PERMIT

SEWAGE DISPOSAL SYSTEM

MARYLAND STATE DEPARTMENT OF HEALTH

SUBDIVISION Kingston ROAD 3534 Kingston Court LOT 7, Sec. 3

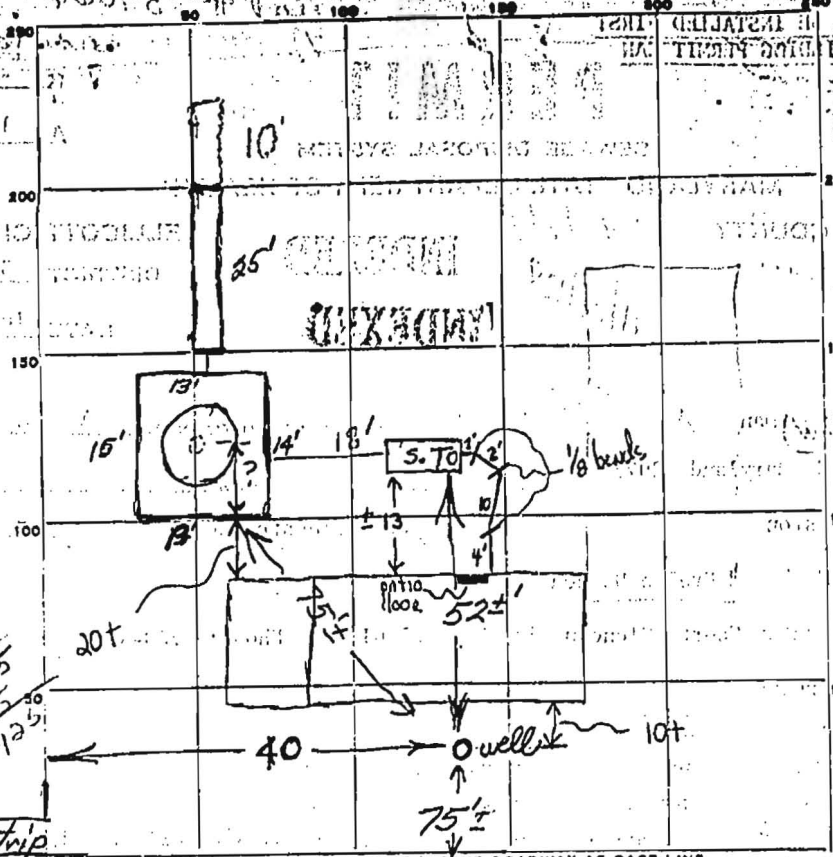
REMARKS 1/6/78. ok to gravel trench, must raise pipe d.w. to trench to no deeper than 3 1/2', raise pipes septic tank to gravel, to rest on top row of blocks, NOT 2nd row. From melt informed installer to add another 20 ft. to trench, near impossible to raise pipes to needed heights to achieve sq. ft.

1/16/78 130 NO FURTHER PROGRESS PH 8 Nov 78 - Gravel in trench -

(no trenching) (not for seepage) Also install gravel in well (not) (GLK on 10' sections)

need 504 #
